RESPONSE TO NOD 1

**AUSTIN COMMUNITY TRANSFER STATION
TYPE V MSW FACILITY
REGISTRATION NO. MSW-40306
AUSTIN, TRAVIS COUNTY, TEXAS**

**Subject: Tracking No. 24549480
Response to Notice of Deficiency – New Registration Application
Austin Community Transfer Station – Travis County
Municipal Solid Waste (MSW) – Registration No. 40306
RN100215938/CN600127856**

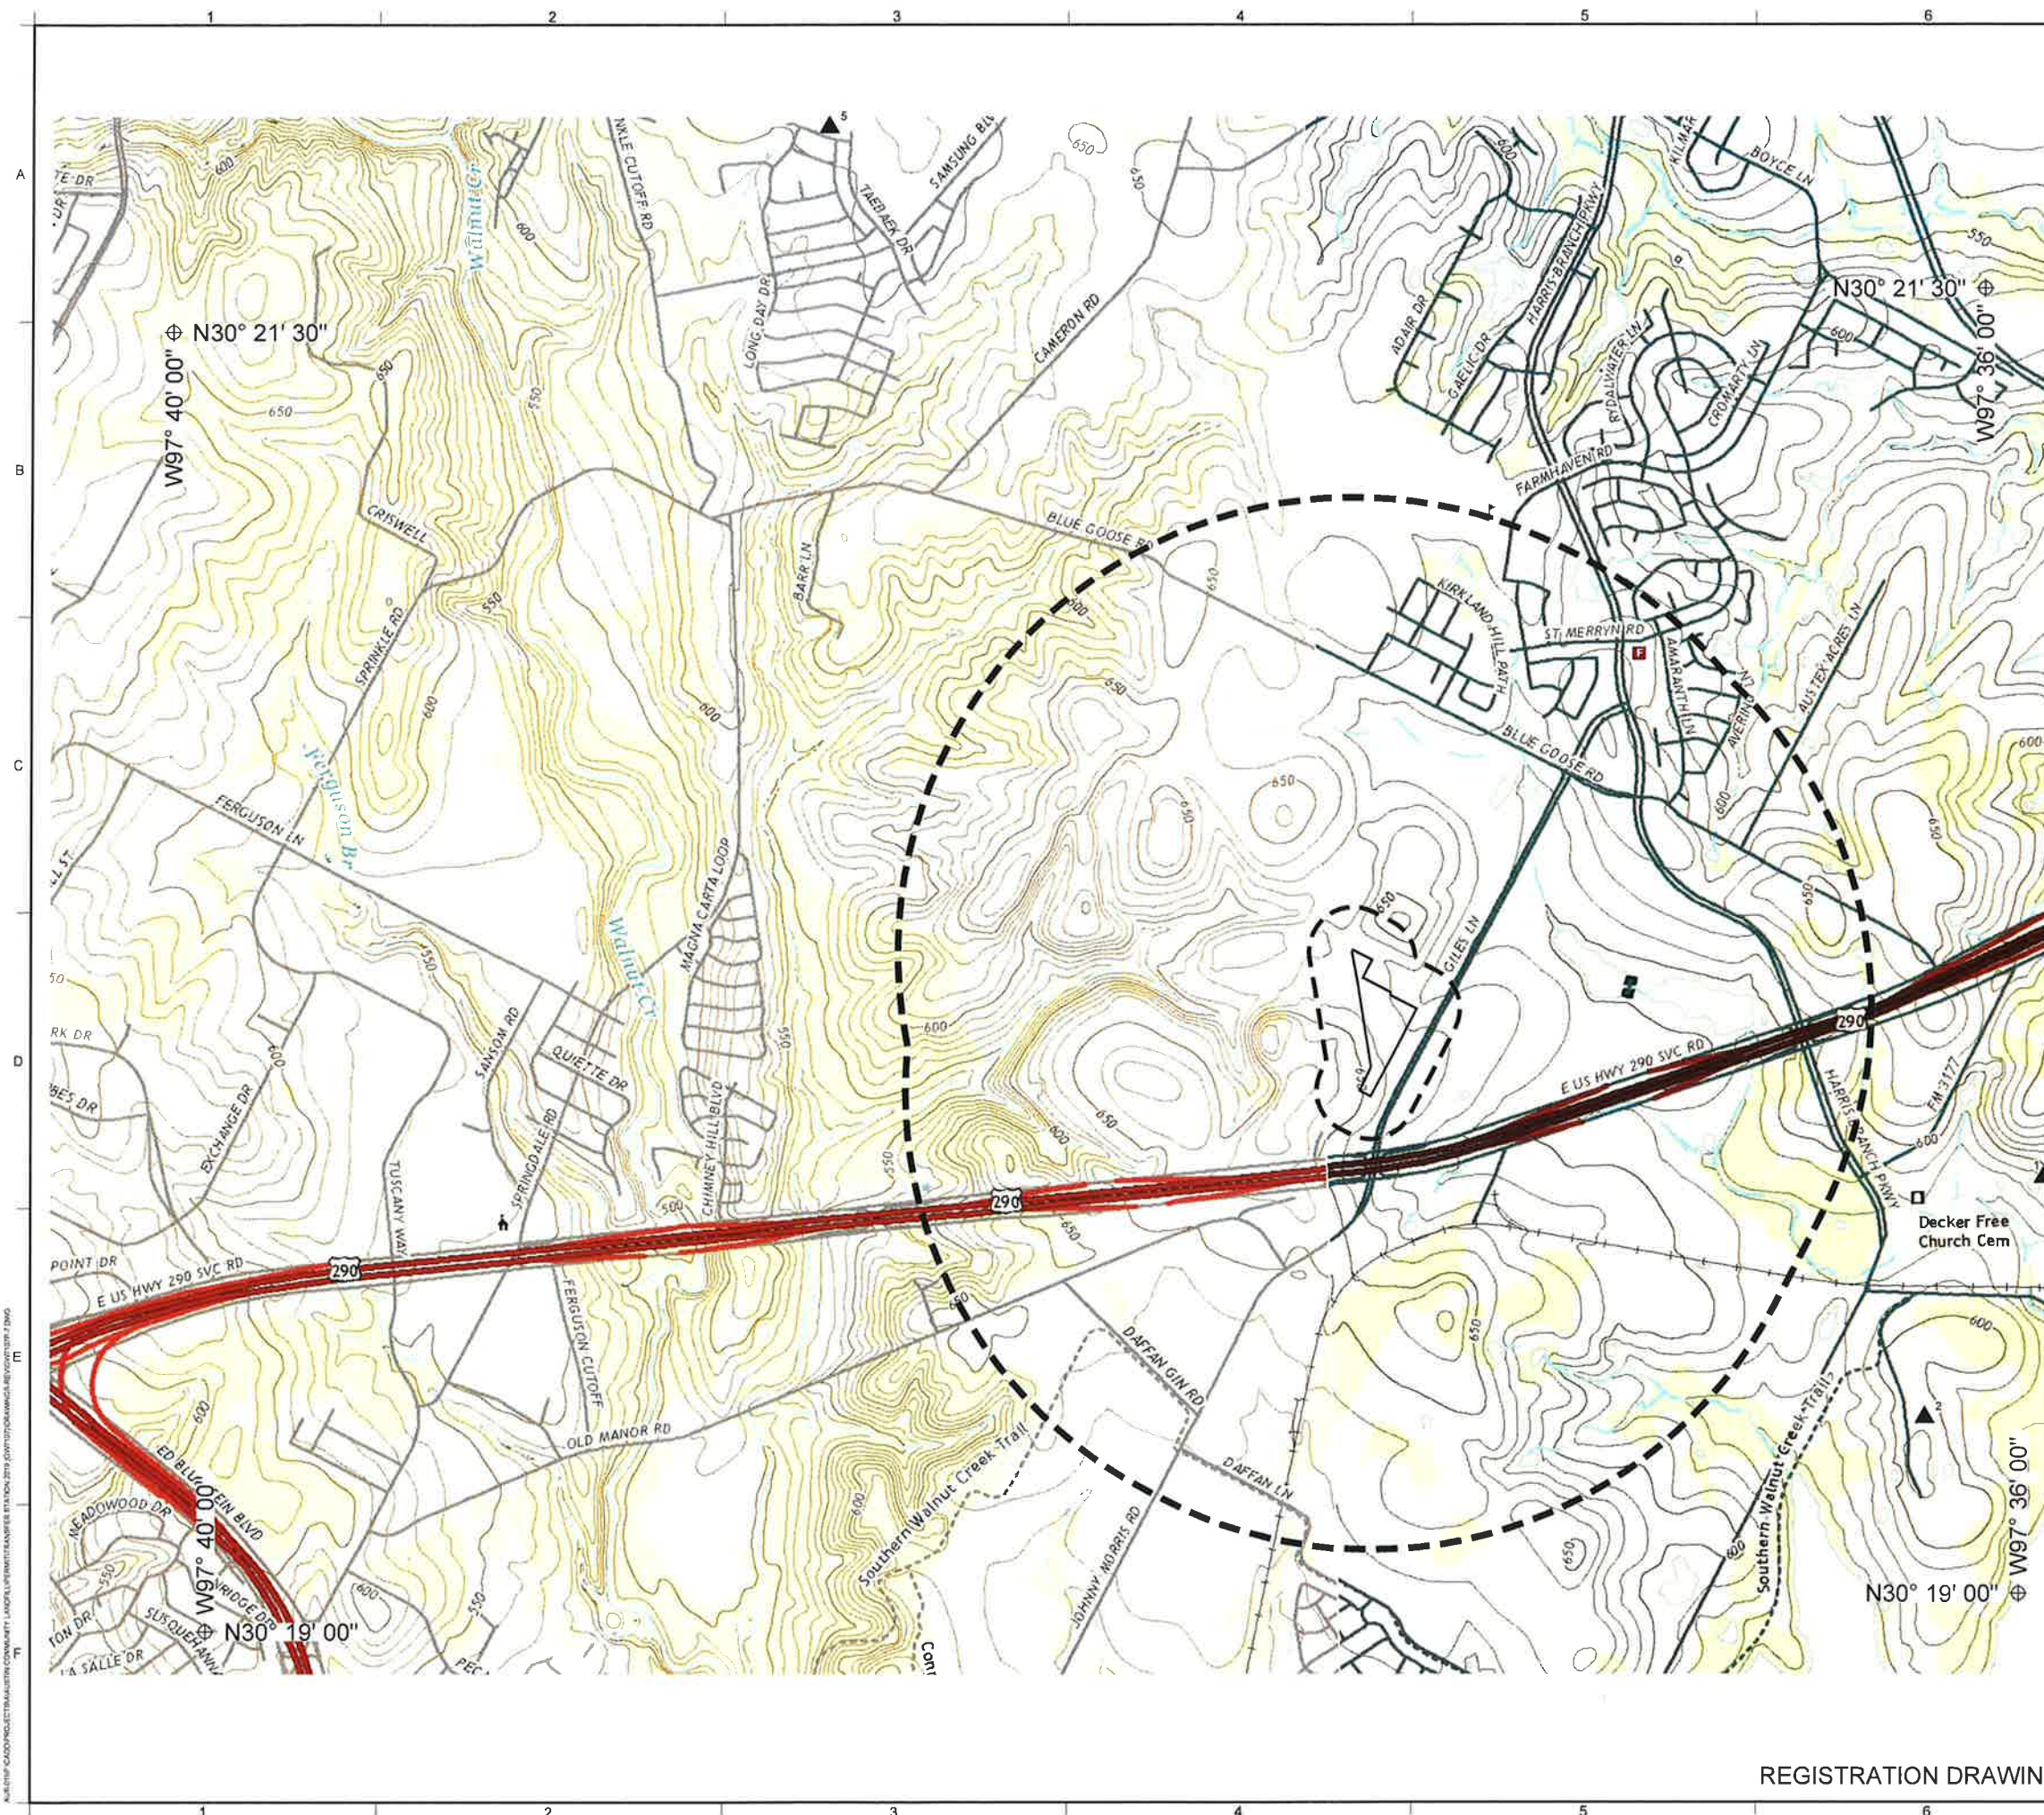
T9	174	Part II	330.61(c)(2)	Part I/II, Appendix I/IIA, Drawing I/IIA-13	Incomplete	Update to include note 3.	The call-out of Note 3 on Drawing I/IIA-13 in Appendix I/IIA of Part I/II was a typographical error; there is no Note 3 on the drawing. Drawing I/IIA-13 has been revised to delete the call-out.
NT10	176	Part II	330.61(c)(4)	Part I/II, Appendix I/IIA, Drawing I/IIA-8	Incomplete	Provide a current land use map.	Drawings I/IIA-8 and I/IIA-9 in Part I/II, Appendix I/IIA provide general and detailed land use mapping information, respectively. In response to this comment, land use mapping data were obtained from the City of Austin in November 2019 and were used to update Drawing I/IIA-9. Drawing I/IIA-9 has been revised to show and reference the source of this latest available land use map. Drawing I/IIA-8 has also been revised with an updated table of surrounding land use percentages within one mile of the facility.

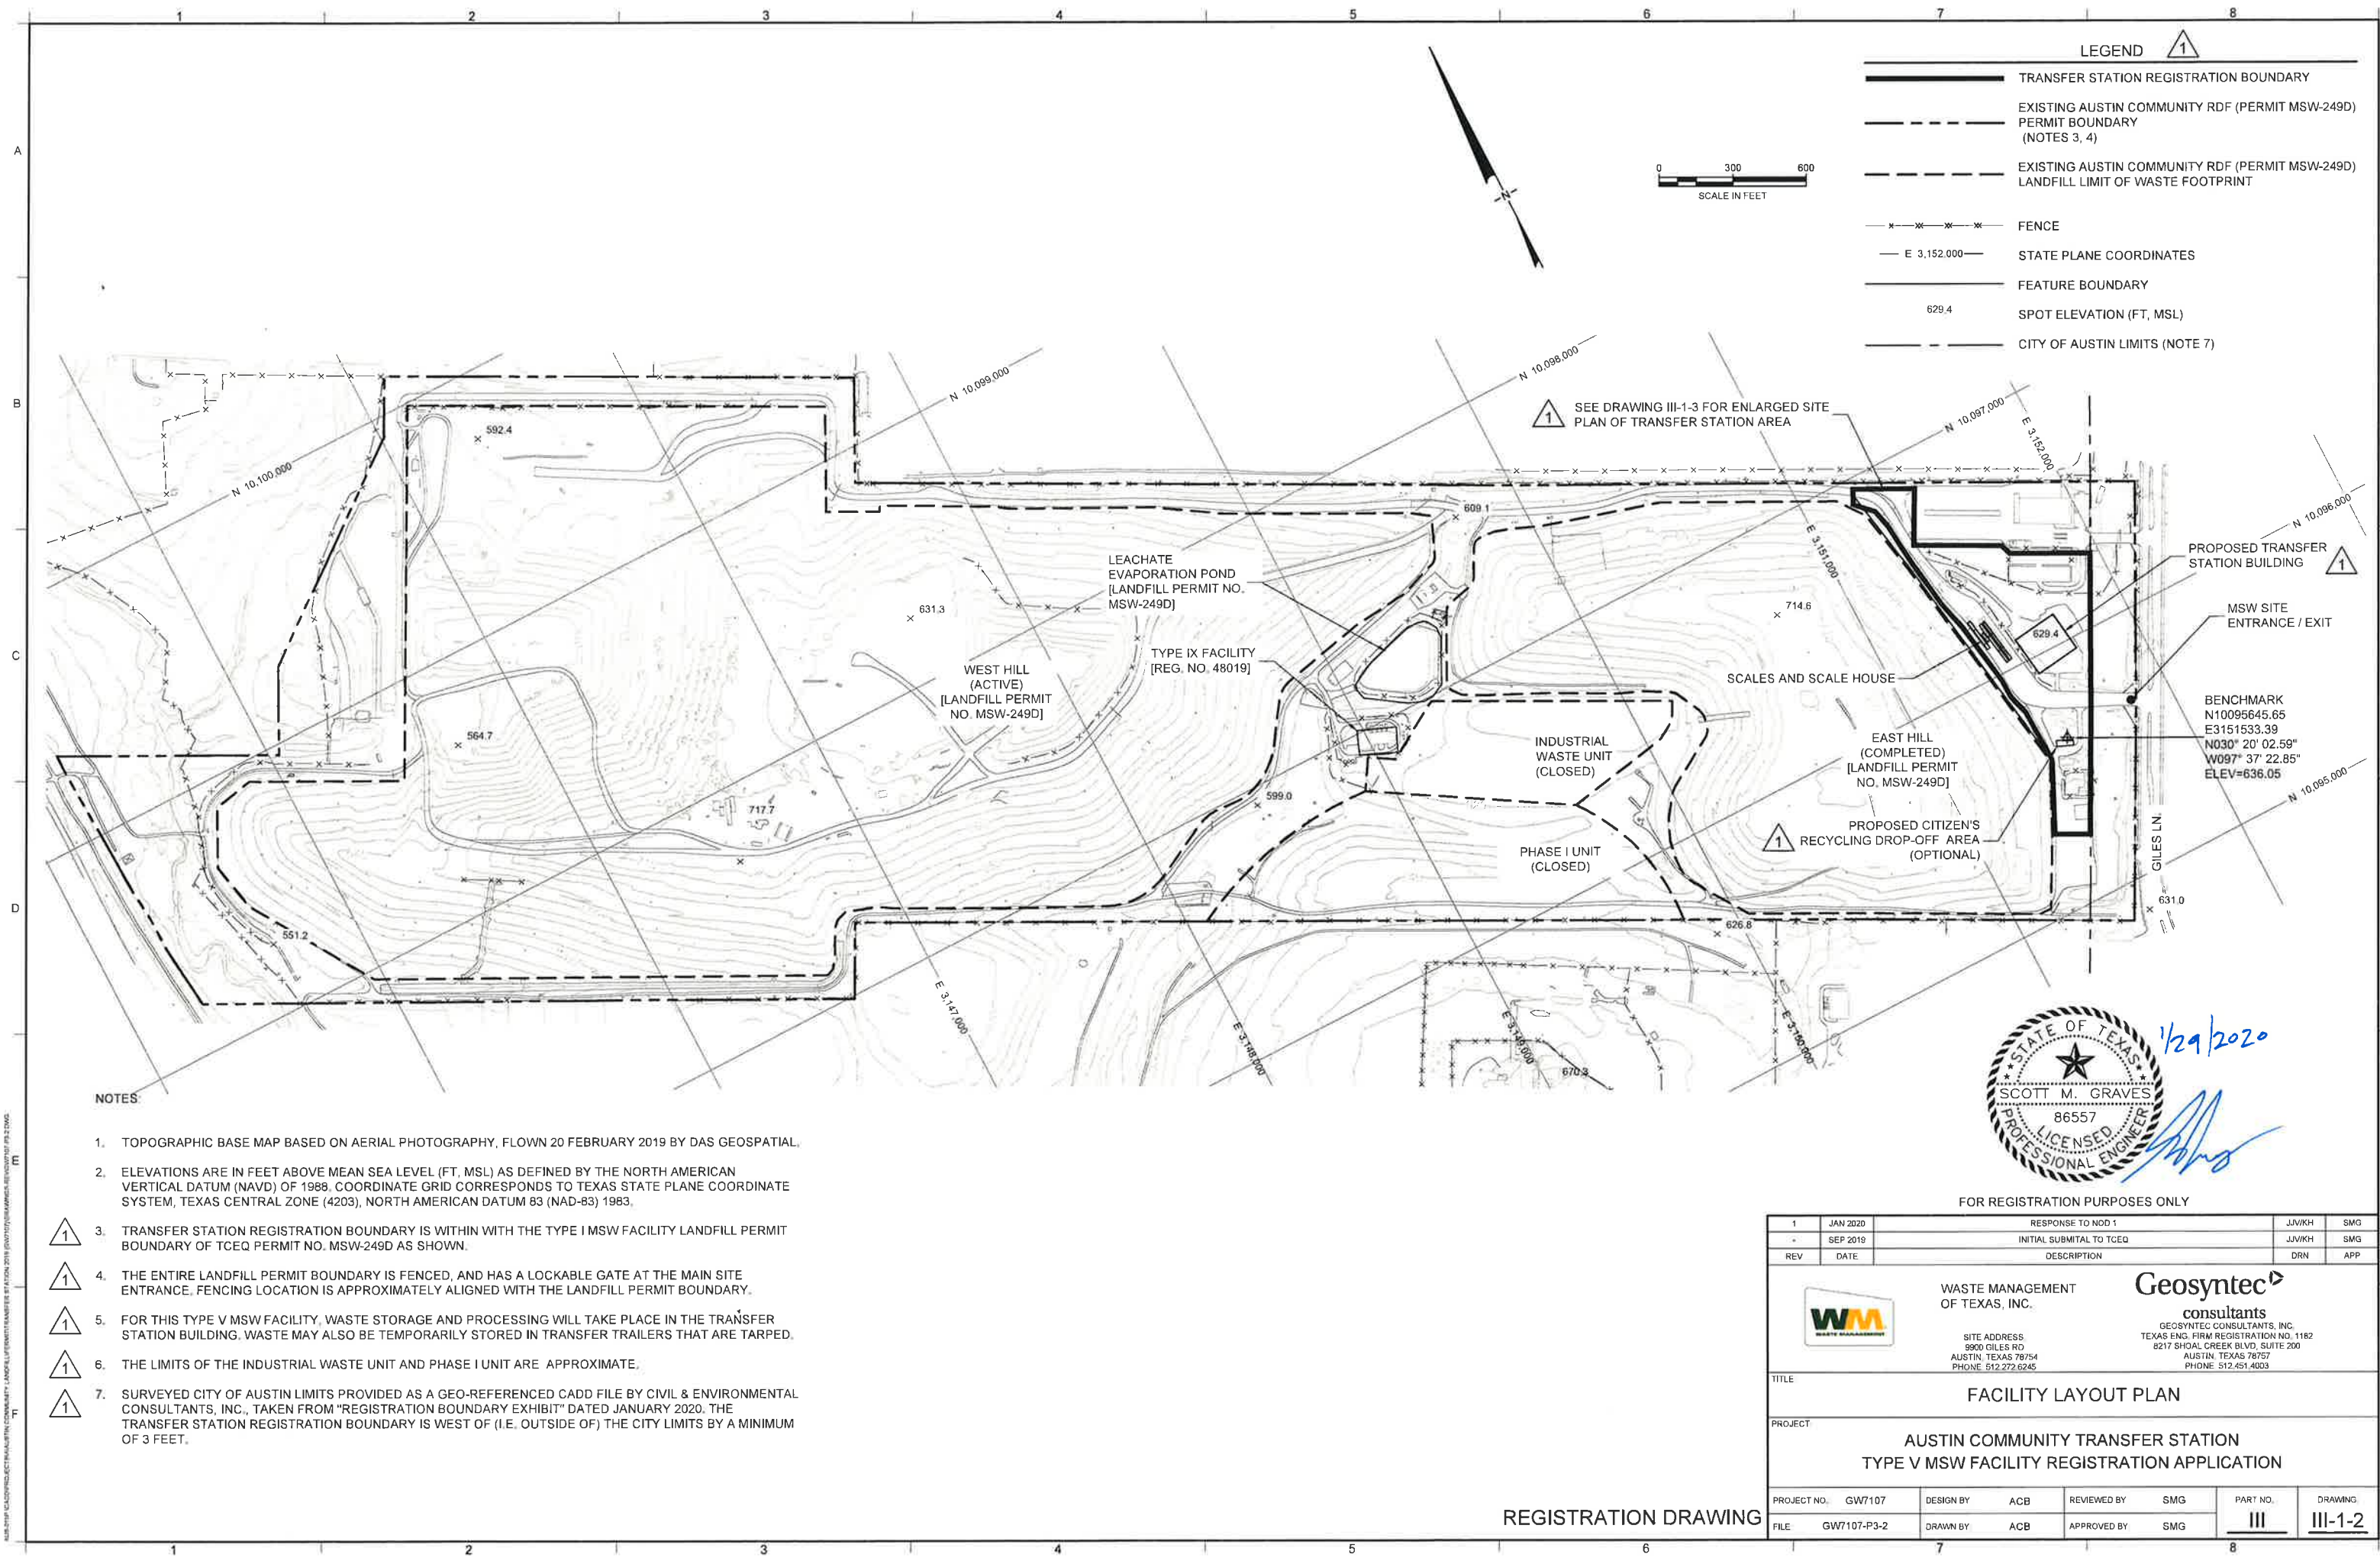
NT23	1027	Part IV	330.209(b)	SOP Section 6.1, Page IV-14	Ambiguous	Provide location of on-site storage for source-separated recyclables.	Section 6.1 of the Part IV SOP (Page IV-14) has been revised to cross-reference Drawings III-1-2 and III-1-4 of Part III, Attachment 1 - which have been revised to show the location of a, optional Citizen's Recycling Drop-off Area that has been designated in an area away from the transfer station waste processing area. Section 6.3 of the SOP (Page IV-15) has also been revised to describe the optional Citizen's Recycling Drop-off Area.
NT24	1029	Part IV	330.211	SOP Section 6.1, Page IV-14	Incomplete	Address type of containers for storage of waste containing food waste.	Section 6.2 of the Part IV SOP (Page IV-14) has been revised as requested to address the specific rule requirements regarding storage of waste containing food wastes.
NT25	1038	Part IV	330.219(a)	SOP Section 2, Page IV-2	Incomplete	Provide off-site location.	Section 2 of the Part IV SOP (Page IV-2) has been revised as requested.
